Memorandum

TO: Columbia River Crossing Task Force
FROM: CRC Pedestrian and Bicycle Advisory Committee (PBAC)
SUBJECT: PBAC Recommendations for World Class Pedestrian and Bicycle Facilities

Columbia River CROSSING

PBAC Proposed Pedestrian and Bicycle System for Replacement Bridge

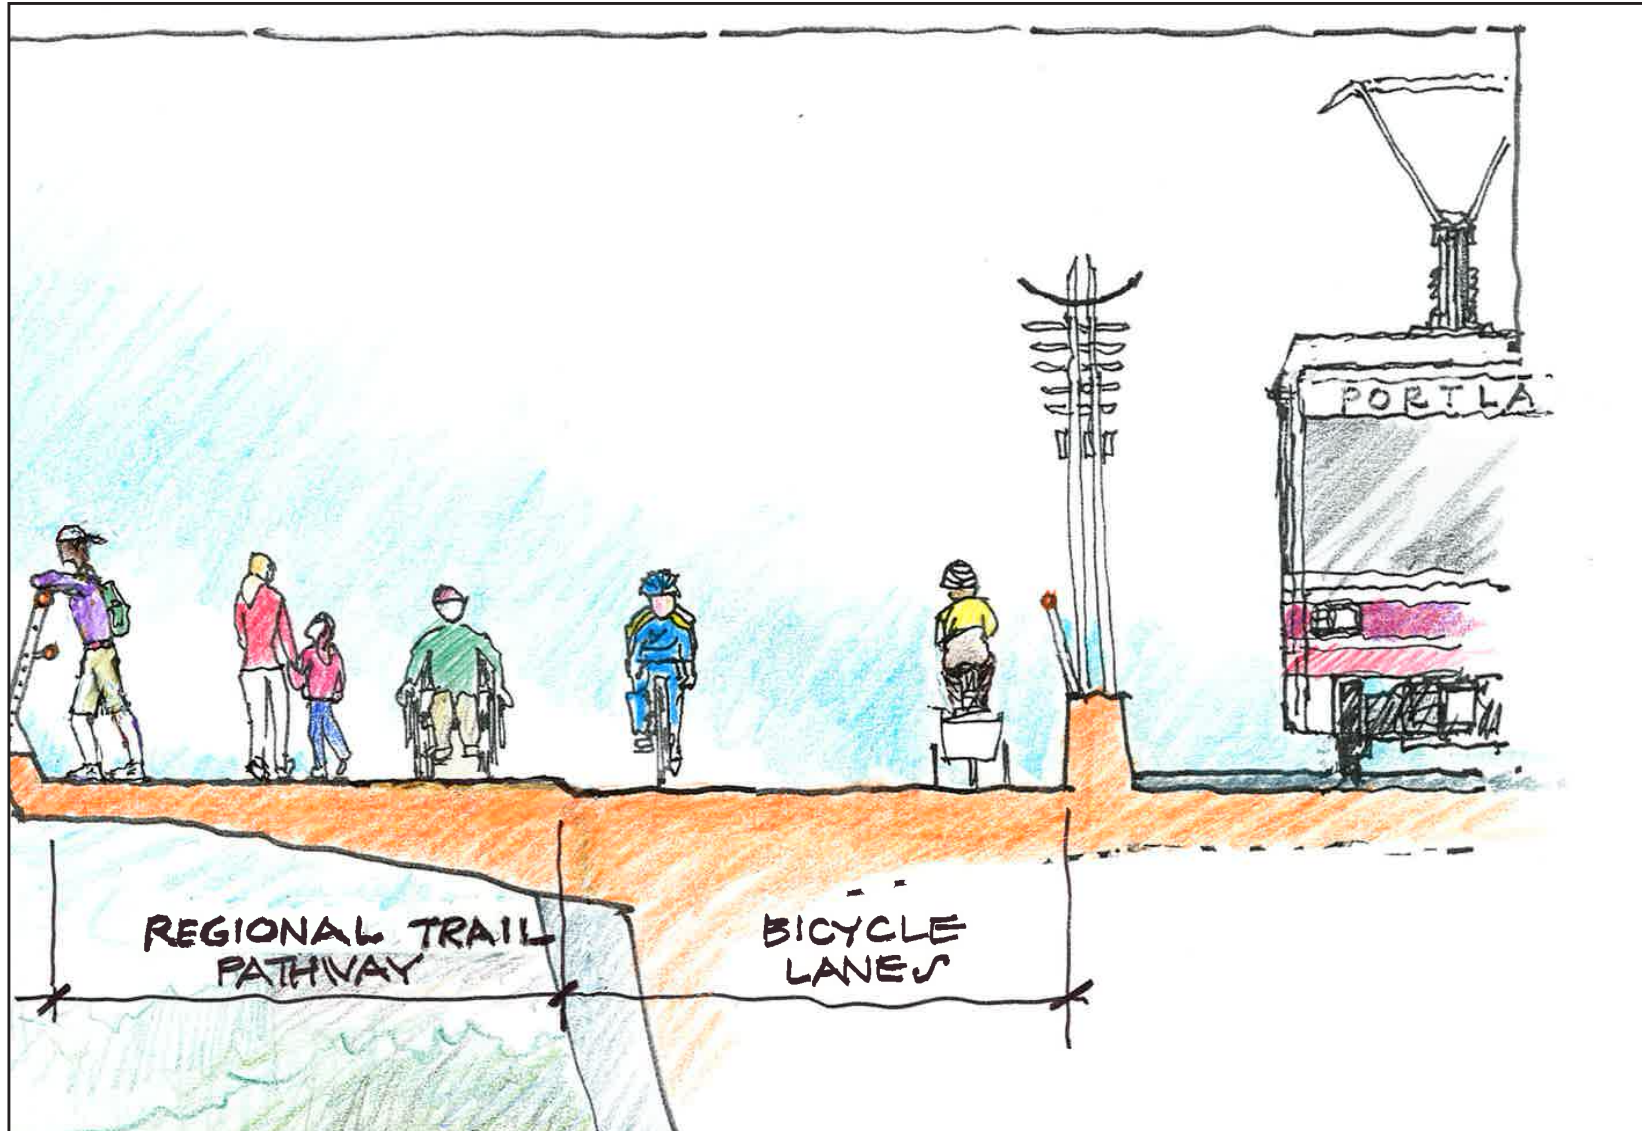
- The overall pathway on the western bridge (adjacent to the transit guideway) must provide separation between recreational users and higher speed bicycle users. To provide this separation, a 12-foot wide regional trail should be provided adjacent to, and to the west of, a pair of six-foot wide bicycle lanes (see attached rendering). These recommended widths are exclusive of potentially needed shy distances, i.e., free and clear of poles and other obstructions to enable safe pedestrian and bicycle movement (a summary of agency standards for multiuse paths, sidewalks and bike lanes is attached).

- In addition to the combined regional trail and bicycle lanes on the western bridge, an eight-foot wide sidewalk should be provided on the eastern bridge (the bridge that would serve the northbound traffic lanes) across both the Columbia River and the North Portland Harbor. The sidewalk across the North Portland Harbor would touch down on Hayden Island and use surface street sidewalks to connect to the sidewalk across the Columbia River.

Pedestrian and Bicycle Advisory Committee Recommended Pathway on West Side of West Replacement Bridge (Looking North)

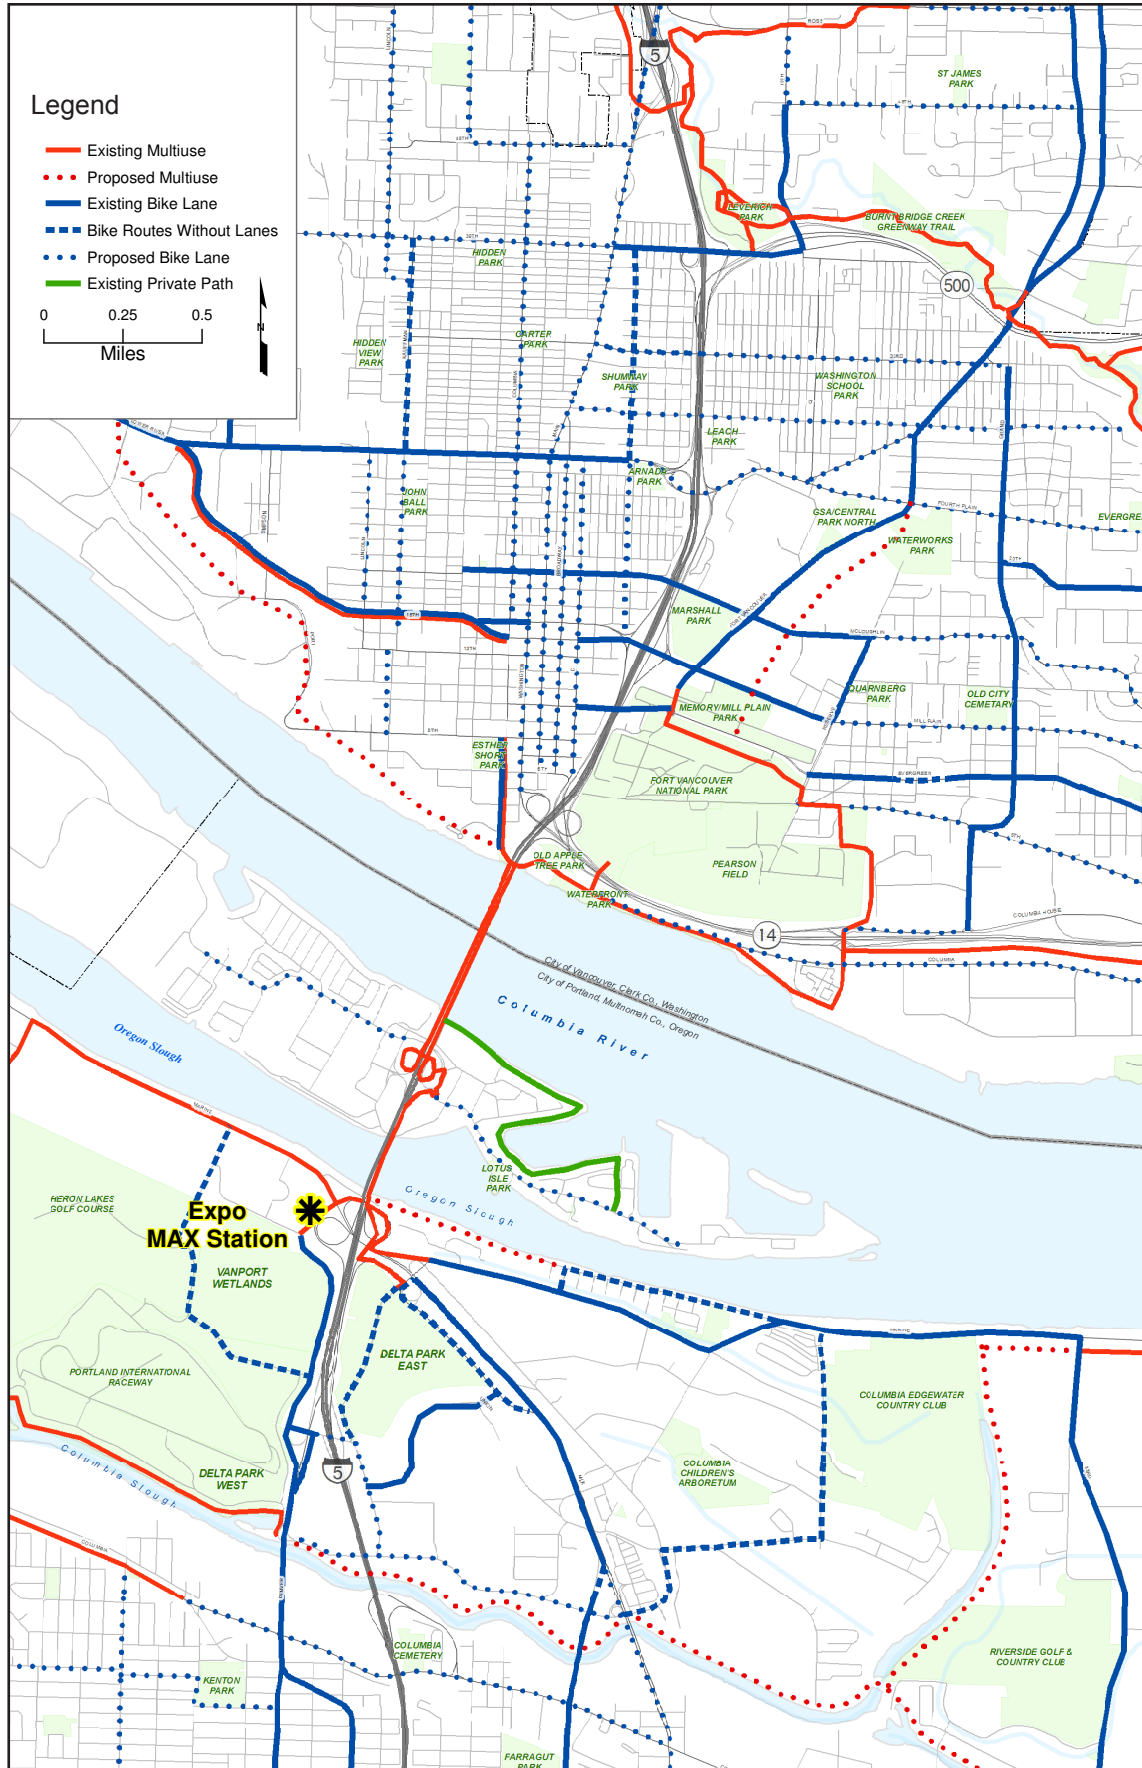
The regional trail would accommodate pedestrians, persons with disabilities, seniors, families with children, tourists, roller-skaters, and recreational bicycle riders. The adjacent bicycle lanes would be used by bicycle commuters and other faster-moving bicyclists. The regional trail would be at a slightly higher level than the bicycle lanes, but bicyclists in the bicycle lanes would be able to access the trail. Different paving treatments and/or patterns should differentiate the regional trail and the bicycle lanes.
